Section 4.7 Hazards and Hazardous Materials Comments

pg 4.7-1

Figure MP4.7-1

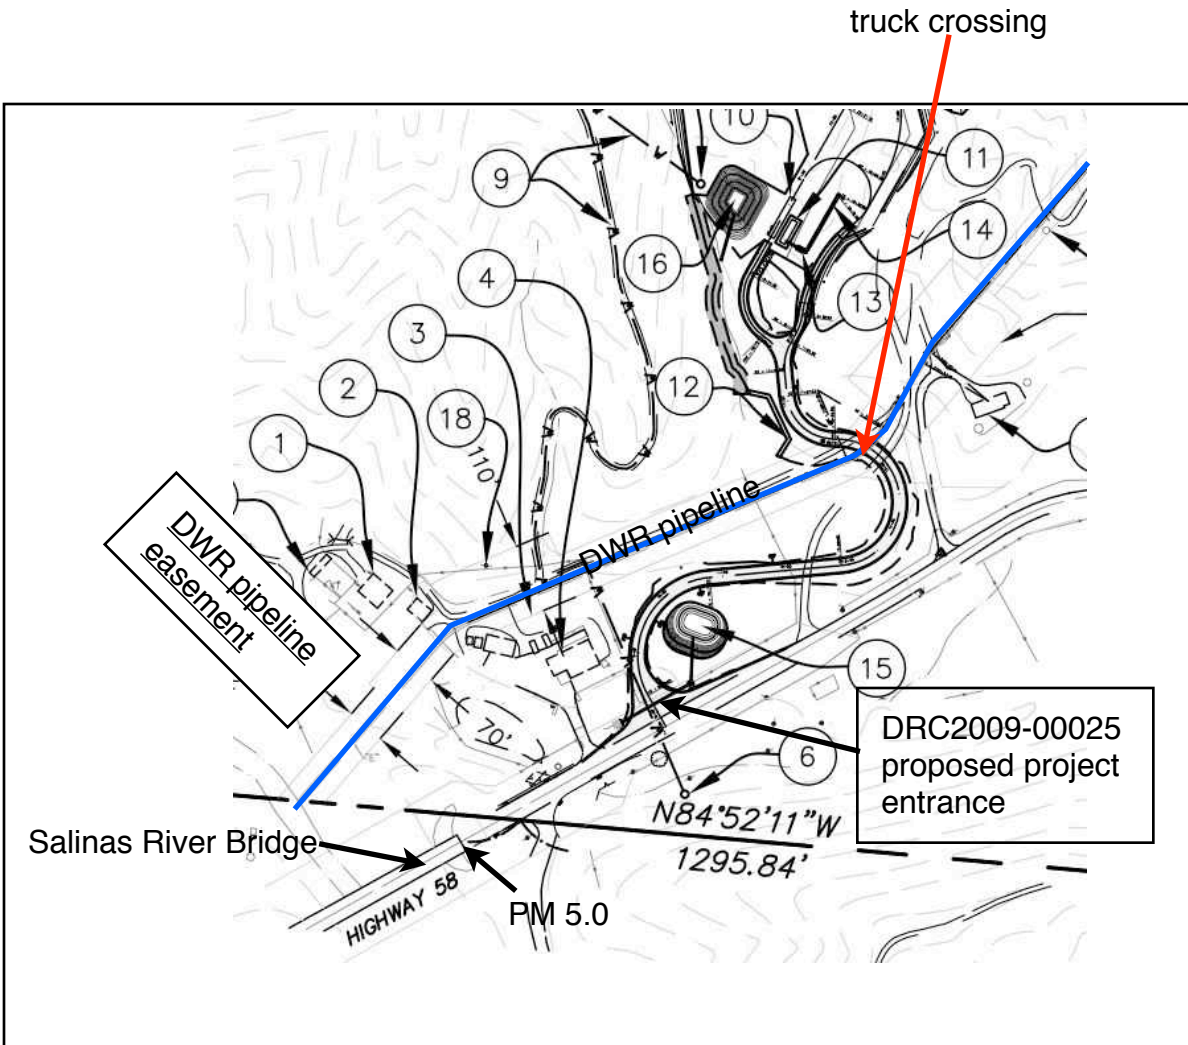
- Using current truck trip calculations (pg. 2-8), more than 65,000 trucks will cross over the aqueduct beneath the access road into the quarry each year for the next 28-58 years.
- Staging of as many vehicles as possible in the incoming (uphill) lane is planned.

- It is foreseeable that vehicle malfunctions, onsite accidents, congestion due to the constraints of a steep road with several swithbacks, and any number of other events, could cause trucks to rest atop the aqueduct for extended periods of time.
- This event has not been adequately addressed.
- Drawings, engineering, and input from DWR (owner of the aqueduct) are not included as part of the DEIR.
- The impacts (flooding, significant environmental degradation, etc.) associated with a rupture in the aqueduct have not been considered adequately.

- Blasting is occurring in close proximity to the aqueduct.
- The same concerns regarding impacts associated with a rupture existing around truck activity exist around blasting.
